Planning and Zoning Board Agenda August 11, 2020

- C. Site Plan – Burger King (16130 NW US Highway 441): A request by Robin Kendall of Quality Dining, Inc., applicant and agent, for T&H Property Group, LLC, property owner, for consideration of a Site Plan to construct a ±3,349 square foot quick service restaurant with associated parking, stormwater, landscaping, and site improvements on a ±1.19 acre subject property. Tax Parcel Number 03061-004-001 (Quasi-Judicial Hearing).

PREPARED BY: Justin Tabor, AICP, Principal Planner

SHEET
C06

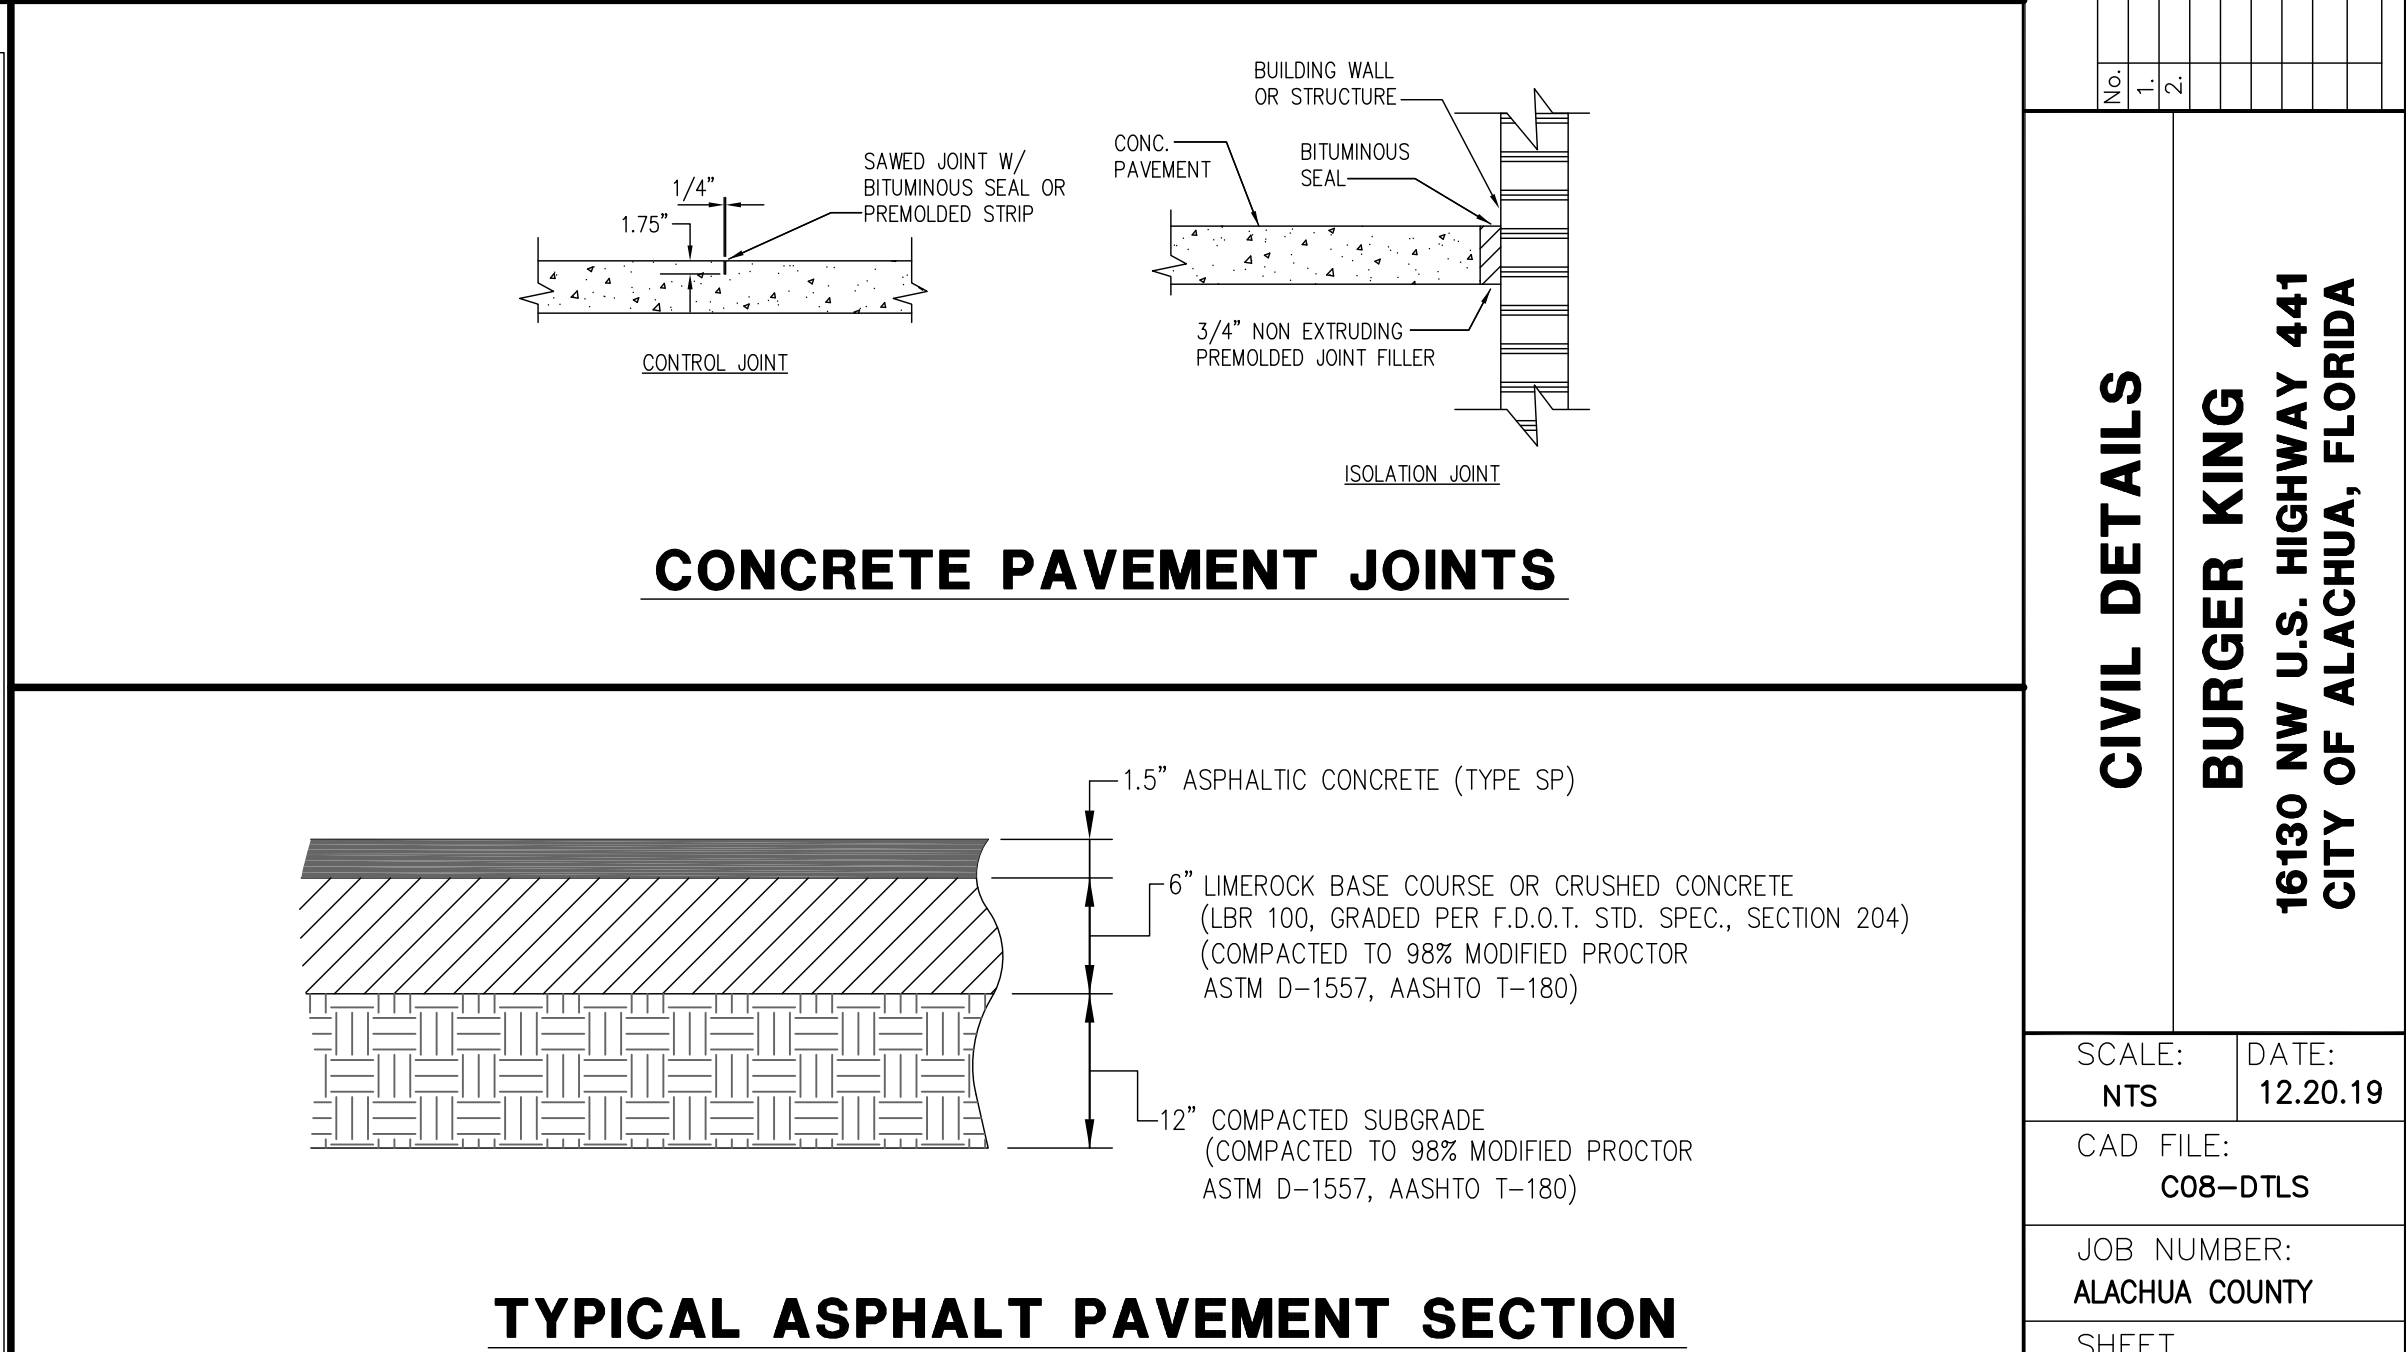
4.	Comment on Jan 12th Submittal • Sheet C06, Note 4: Please review meaning of “conveyed”? Should it instead be “connected”? • Sheet C06, General Utility Note 9: Please add “electric service”. • Sheet C06, Please add the following general note: “In the right-of-way, to both the 2-inch water line and 6-inch gravity sewer main, install 2-pair, 10- gauge tracer wire with enough unwrapped wire to allow connection to test device.”

5.	Comment on Jan 12th Submittal • Sheet C06, Electrical: The electric service will not be provided from the overhead line and power pole. Instead show a pad-mounted transformer close to where the power pole is. Also, show a new underground electric line from the Utility Box to the pad-mounted transformer. • Sheet C05, Electrical: Please add the following General Utility Note: “The City of Alachua will procure and install the pad- mounted transformer, the pad and also the conduit & conductors from the utility box to the pad-mounted transformer. This work shall be done at no cost to the City, who will backcharge the Contractor. All electric work “downstream” the transformer shall be the responsibility of the Contractor”.

6.	Comment on Jan 12th Submittal • Sheet C06, Electrical, The City of Alachua will provide 277/460 Volt 3-phase electrical power at the transformer. Please confirm that this is acceptable. Other power types may be available. • Sheet C06: Please provide a load schedule so that the City can size the transformer. When will the load schedule be available?

7.	Comment on Jan 12th Submittal • Sheet C06, Cleanout: A cleanout is shown within the property line in the lower left. Please either: • Relocate the cleanout so it is in the right-of-way, or: • Keep as is, but add a second cleanout in the right of way, or. • Keep as is, but grant an easement to access the cleanout.

NO.	COMMENTS
8.	Comment on Jan 12th Submittal Sheet C06: Where the new 2-inch water line connects to the existing 16-inch DIP, a corporation stop is called out. As per CoA standards, please replace with a 2-inch resilient seat gate valve with valve box.

9.	Comment on Jan 12th Submittal Sheet C06: A dashed line is shown about 10 feet within the property line. What does it represent? Please show on legend sheet.

Response: Yes. See revised sheet C06.
